City of Oxford
Community Development Department
STAFF REPORT
Board of Zoning Appeals

Case # BZA-12-2010

Action Request: Variance to Section 1141.03(e)(2), Section 1149.04(a)(3) and Section 1149.04(b)(3) to allow for a new house to exceed the maximum front yard setback of 30' and to allow an existing driveway and parking area to encroach into the side yard setbacks.

PETER & CONNIE MCCARTHY
PROPOSED LOT SPLIT & NEW HOUSE FOOTPRINT

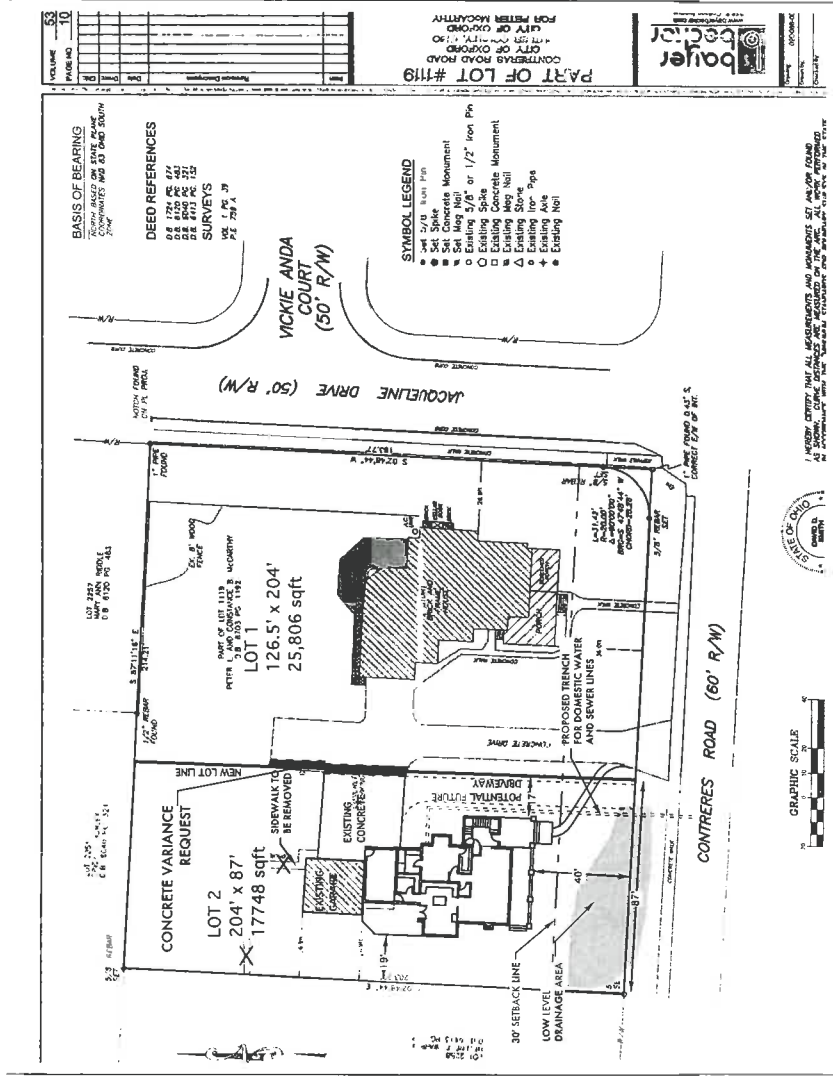
- *The proposed lot split meets the underlying size and dimensional requirements for the required lot width, area and proposed use, but cannot be approved until variances are received regarding the parking & driveway setback encroachments and front yard setback increase.*

- *The proposed structure is shown as being setback 40'; 10' more than the maximum 30' requirement.*

- *There are existing driveways and parking pad areas that do not meet this requirement from the proposed new property line. The appellant is requesting that the existing driveway may be maintained.*

- *There are existing driveways and parking pad areas that do not meet this requirement from the proposed new property line. The appellant is requesting that the existing driveway may be maintained.*

PETER & CONNIE MCCARTHY
PROPOSED LOT SPLIT & NEW HOUSE FOOTPRINT

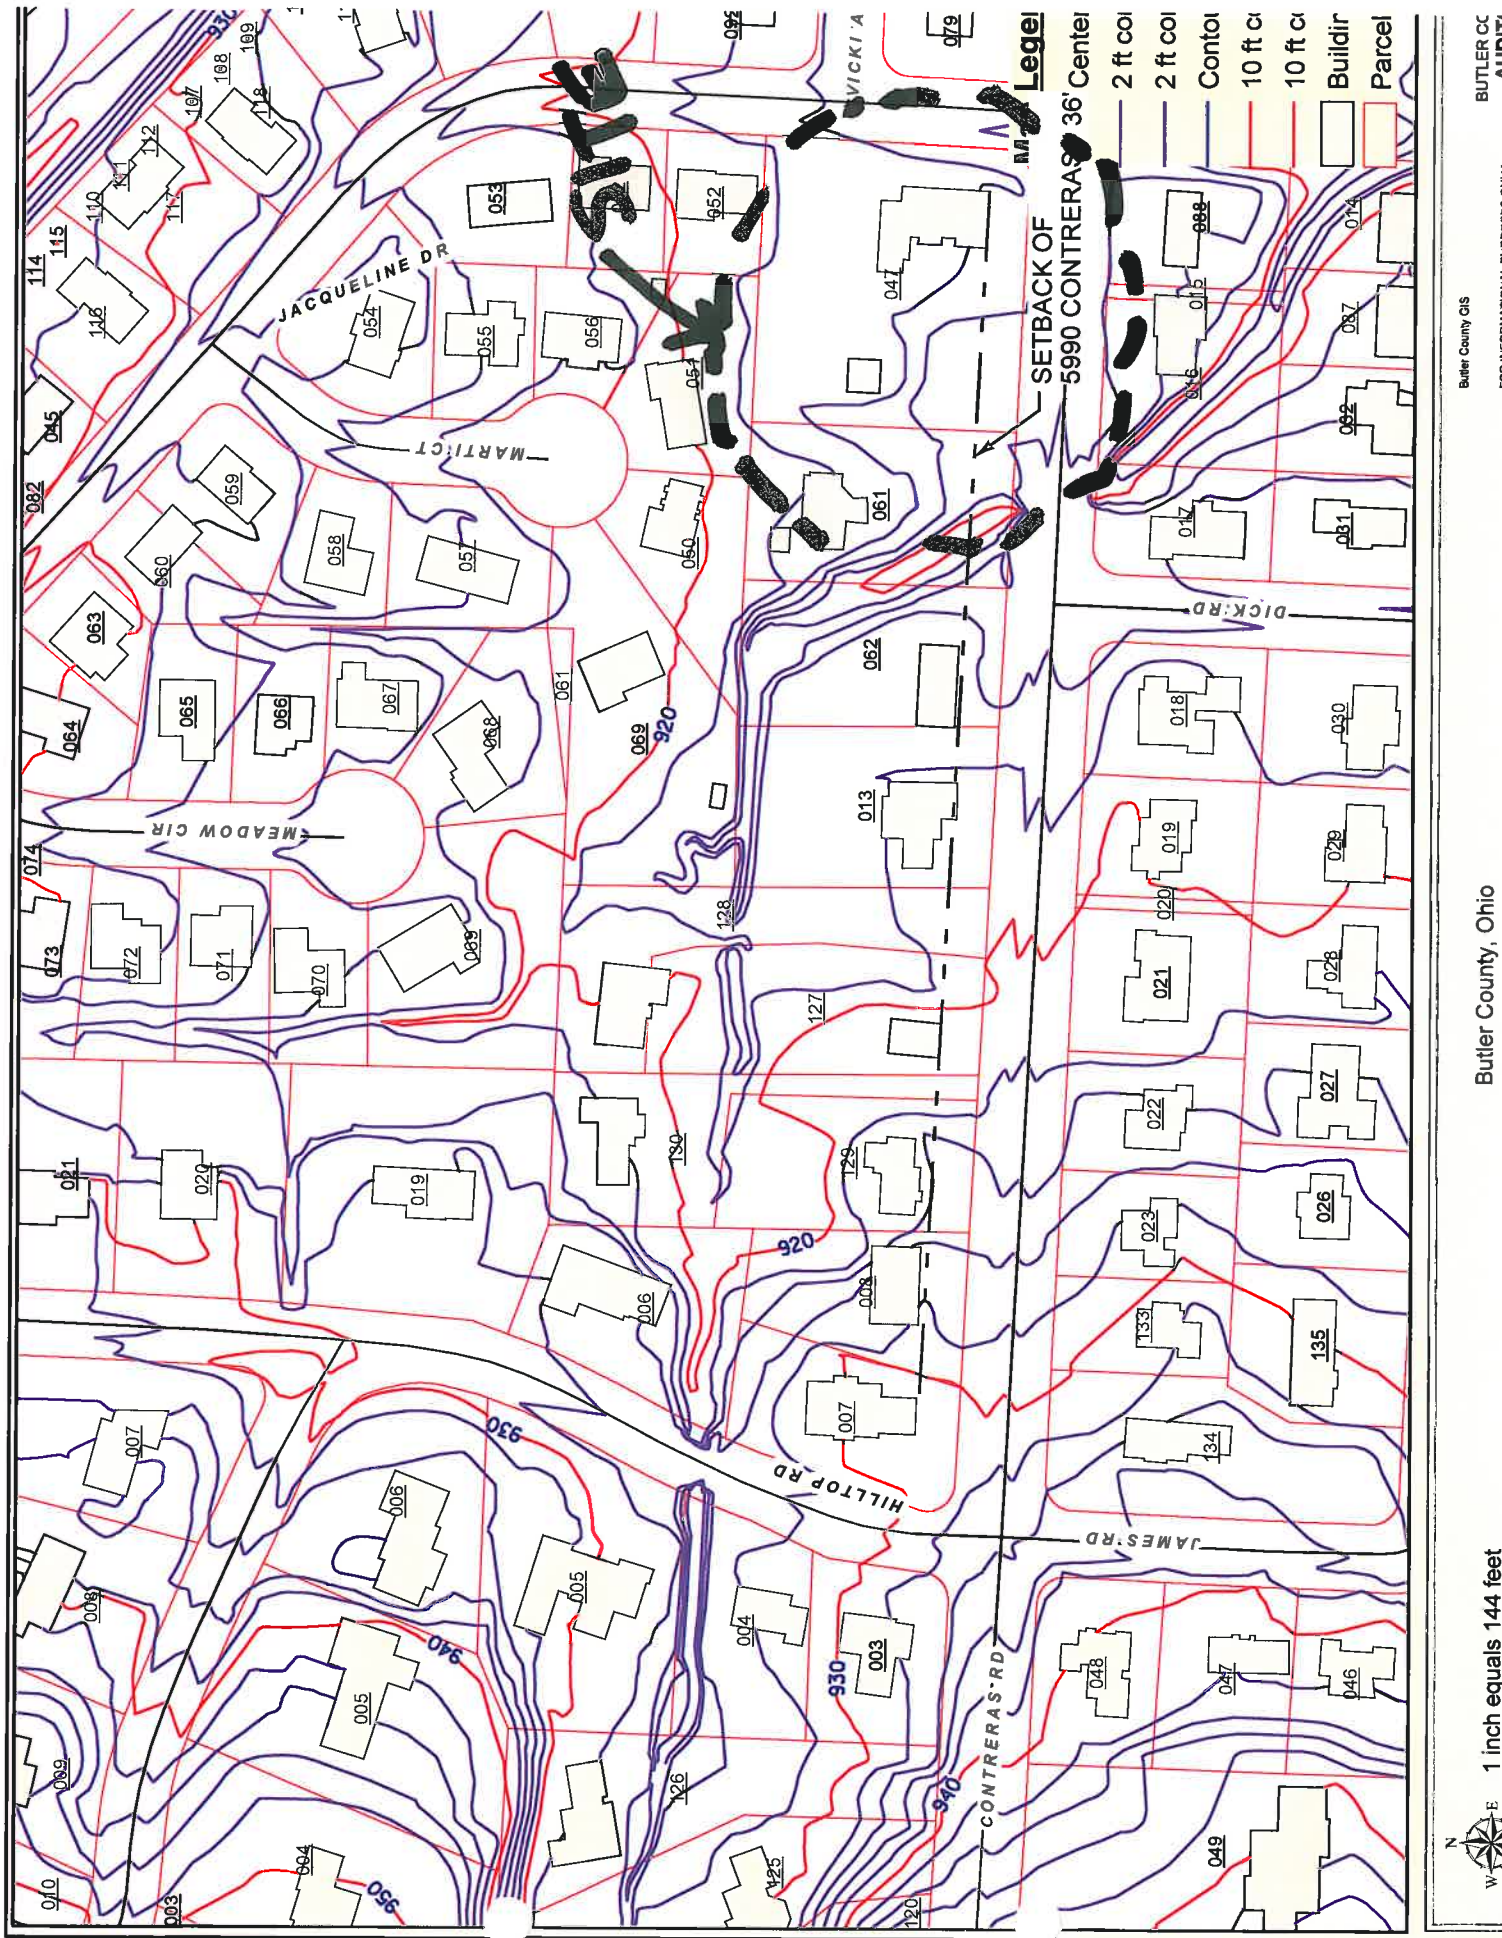
In regards to the front yard setback requirement as relates to zoning code and the surrounding area, staff has analyzed the block face and has found that the average setback along both Jacqueline Drive and Contreras Road exceed the maximum 30 foot setback requirement. Along Jacqueline to Marti Court are four addresses that average 31.5 feet front yard setbacks and along Contreras, heading west, within the "R1B" zoning district are 4 addresses that average a 32.25 foot setback, with the exception of the two flag lots which would then average 77.8 feet. The addition of the flag lots significantly increases the setback average.
